**SUBJECT:** Request for Concurrence with the Explanation of Significant Differences for the North Bronson Industrial Area Superfund Site in Bronson, Michigan

**Explanation of Significant Differences**

**U.S. EPA Region 5  
September 2008**

### **MODIFYING THE 1998 RECORD OF DECISION FOR OPERABLE UNIT 1 OF THE NORTH BRONSON INDUSTRIAL AREA SUPERFUND SITE**

Figure 1

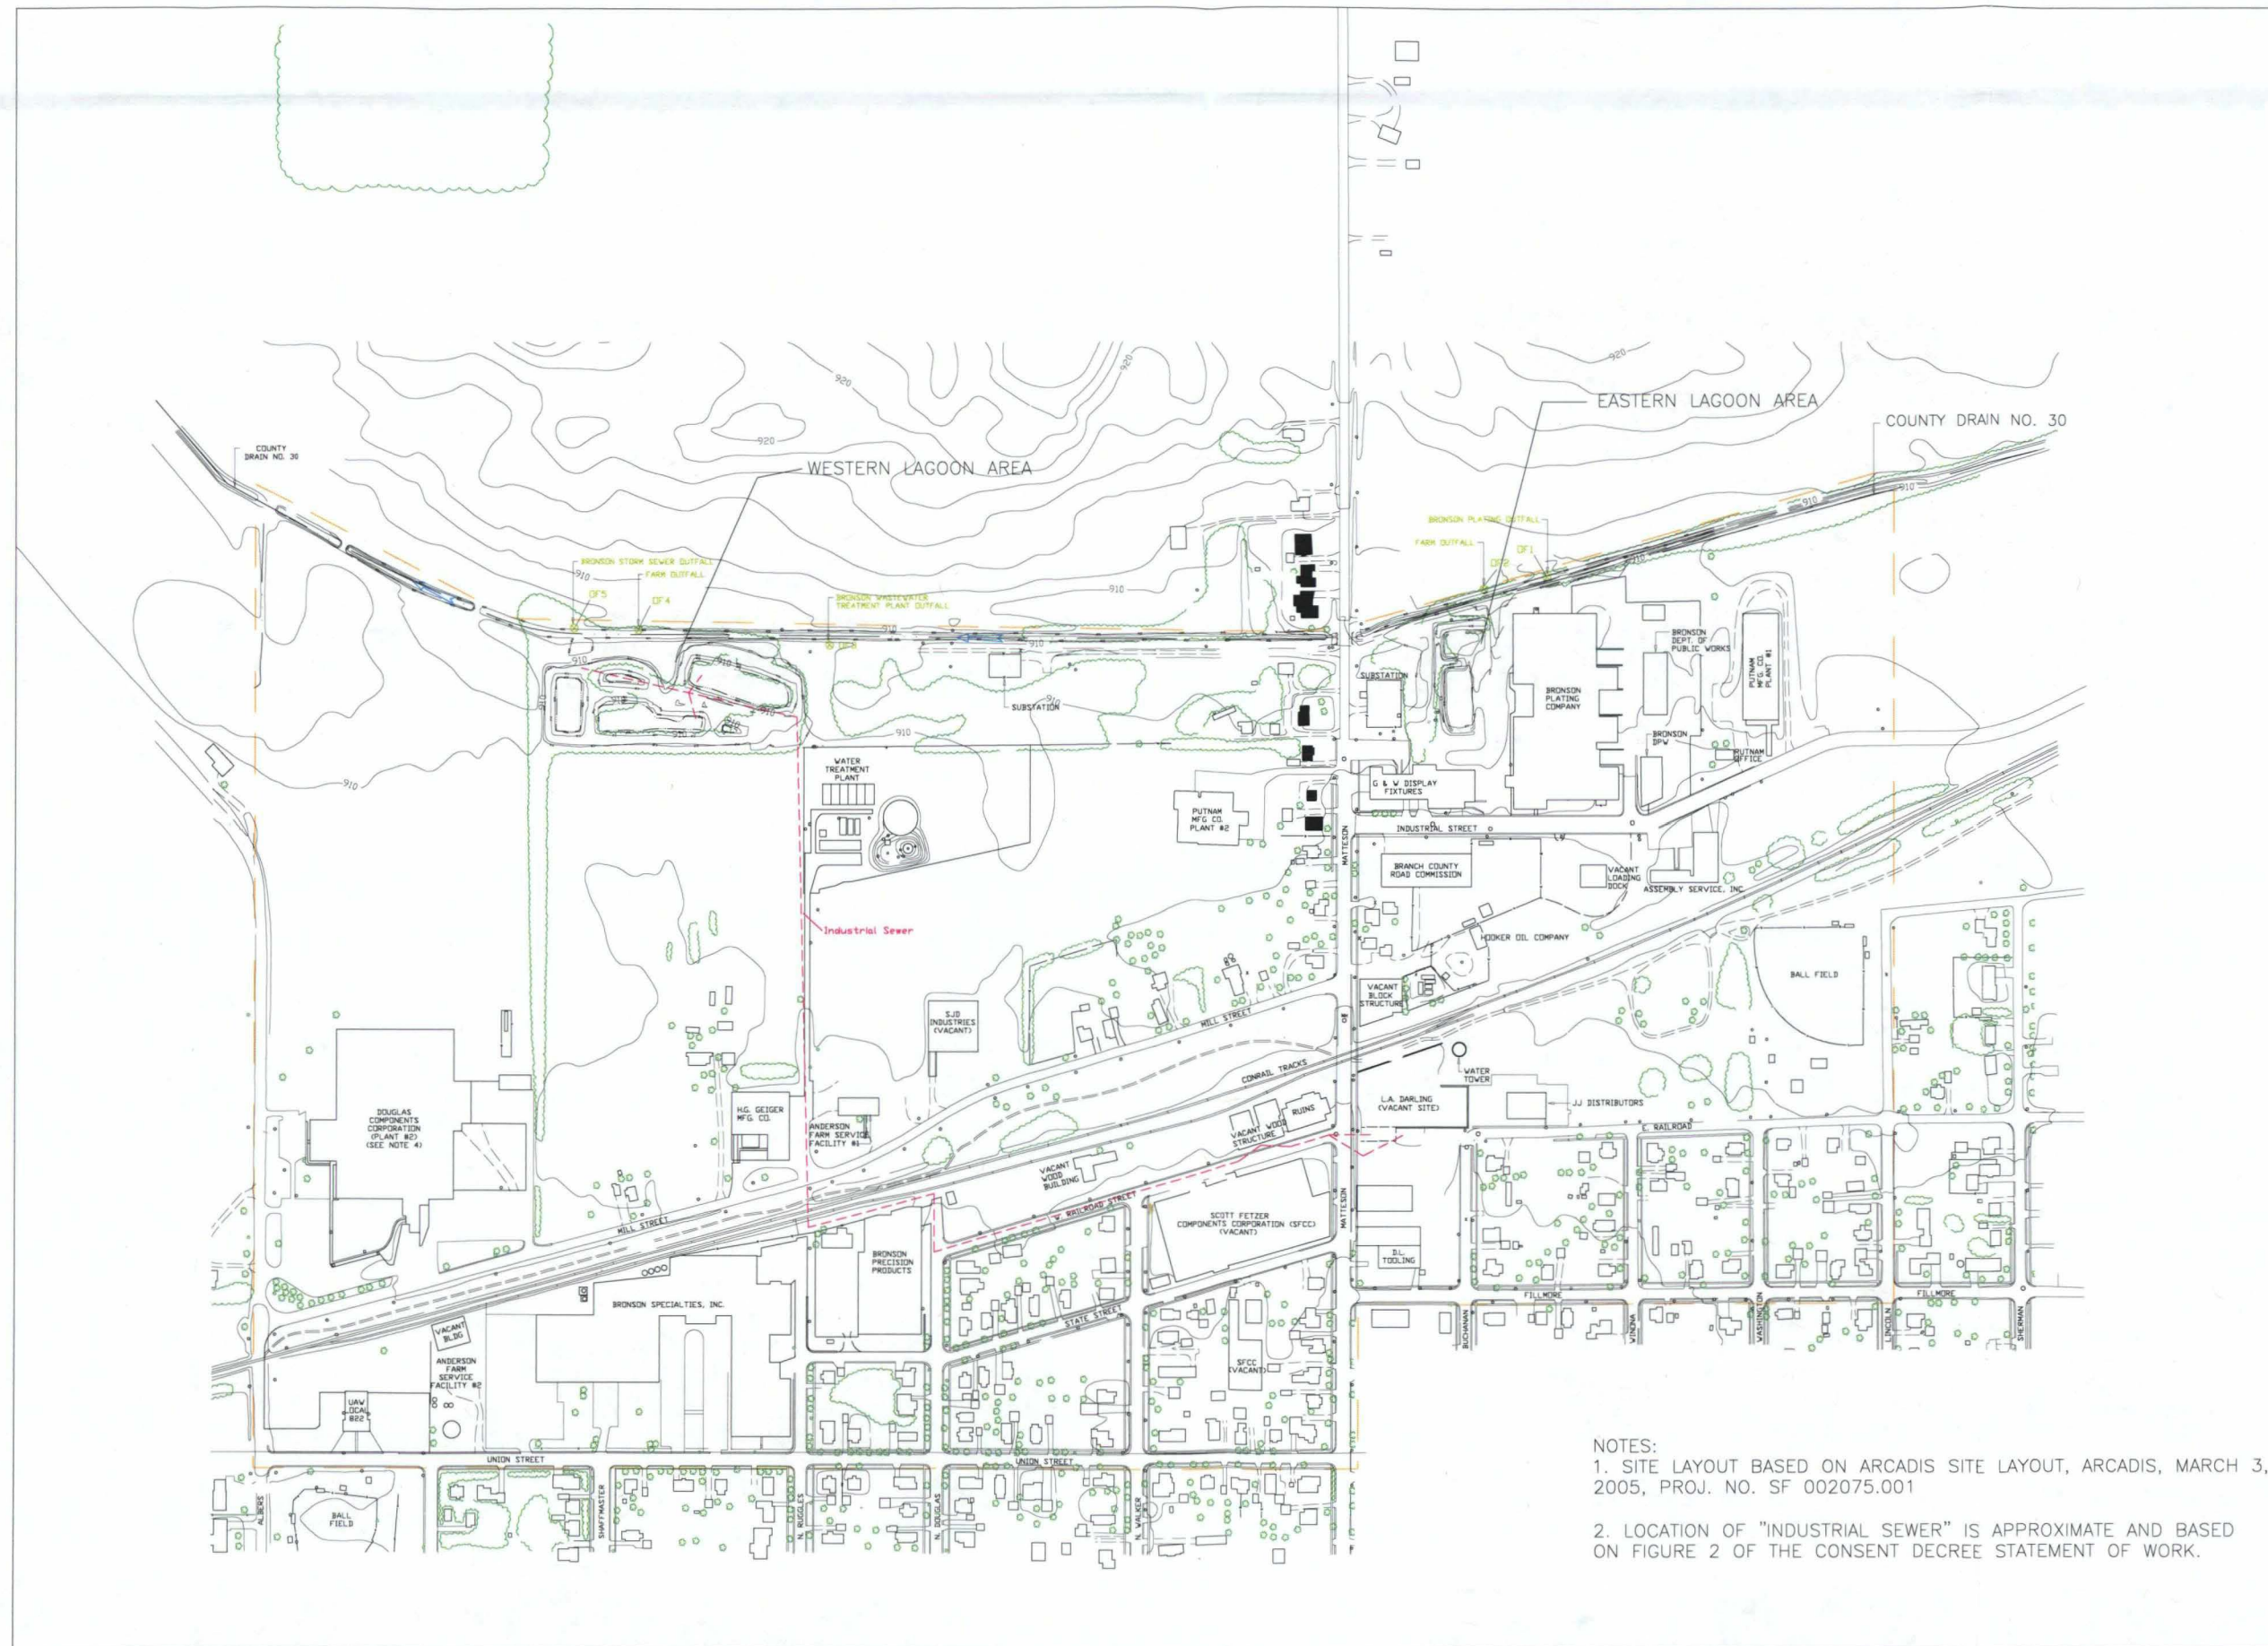
The North Bronson Industrial Area Superfund (NBIA) Site is located in Bronson, Michigan. The Site includes two lagoon areas, a county drain that runs adjacent to the lagoons, the sewers used to transport wastewater to the lagoons, and associated contaminated groundwater (see Figure 1). Operable Unit 1 (OU1) of the NBIA Site includes the lagoons, the county drain, and the contaminated groundwater associated with the lagoons and the drain. A Record of Decision (ROD) for OU1 was issued on June 19, 1998. The sewers and their associated contaminated groundwater are to be addressed in a separate operable unit, designated as Operable Unit 2 (OU2).

This ESD updates the remedy selected in the June 19, 1998 NBIA OU1 ROD by eliminating the requirement for excavation of the eastern lagoons and clarifying what constitutes appropriate containment for lagoon closure. These modifications retain and improve upon the excavation, consolidation, and containment components of the NBIA OU1 ROD. As none of these significant differences is considered a fundamental change to the NBIA OU1 ROD, U.S. EPA has determined that no public comment period is required. Nonetheless, U.S. EPA discussed the possible changes to the approach for lagoon closure in a July 2007 Fact Sheet and at a July 2007 public meeting.
